WASHINGTON COUNTY OREGON

ADA Curb Ramp New Construction Inspection Form (Perpendicular)

Ramp Style: PR

PERPENDICULAR RAMP (PR)

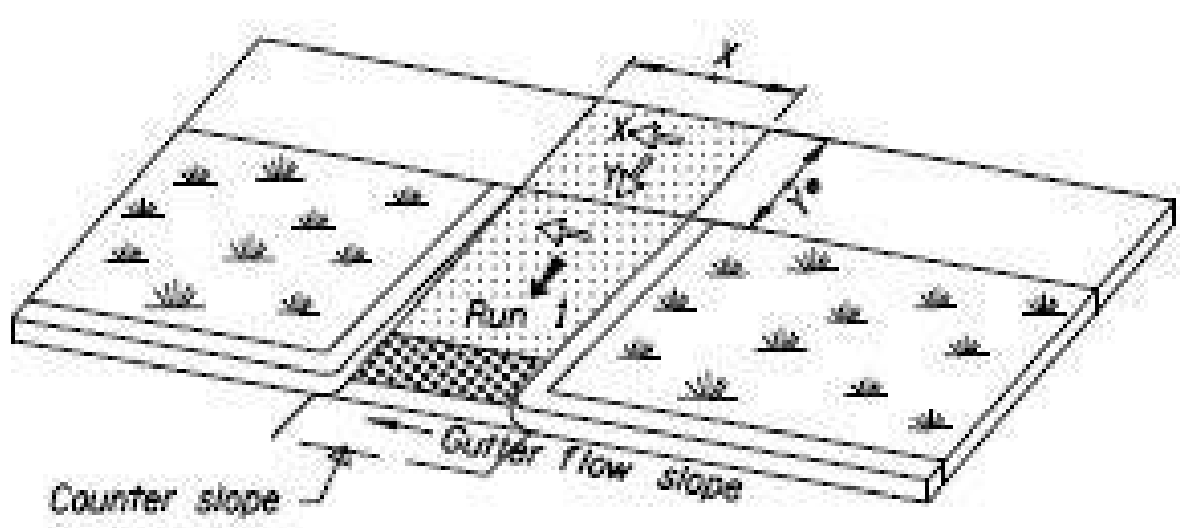
RAMP RUN 1	Value		Pass		Fail	
Running Slope 1	7.4	≤ 8.3%	■	>8.3%	☐
Length 1	4.4					
Cross Slope 1	1.1	≤ 2.0%	■	>2.0%	☐
Detectable Warning (Y,N)	Y	Y	■	N	☐
Lip Height	0	1/4"	■	>1/4"	☐
Gutter Flow Slope (N/A ☐)	0.6	≤ *	☐	>*	☐
Curb Running Slope (avg)	0.64	≤ 8.3%	☐	>8.3%	☐
Counter Slope (+/-) *2	5.4	≤|5.0%|	☐	>|5.0%|	■
Longest distance from corner to back of curb (see dwg on BT form)		< 5.0'	■	≥ 5.0'	☐
Detectable warning extends full width of ramp throat opening	Y	Y	■	N	☐

CS fail in middle
